Technical Bulletin

Model
911 C2/C4
928S/S4/GT

Subject: Caster Adjustment Values

Number
9201

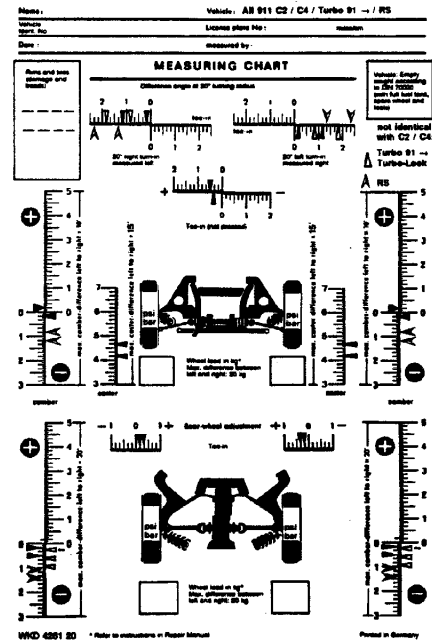
The specified caster adjustment values and tolerances changed in production. The new value of

$$4^{\circ} 25' \begin{matrix} +15' \\ -30' \end{matrix}$$

should be applied to all 911 C2/C4 of all model years. The maximum difference between left and right remains 15'.

Please update your 911 Carrera 2/4 Workshop Manual, Volume IV, page 44-02.
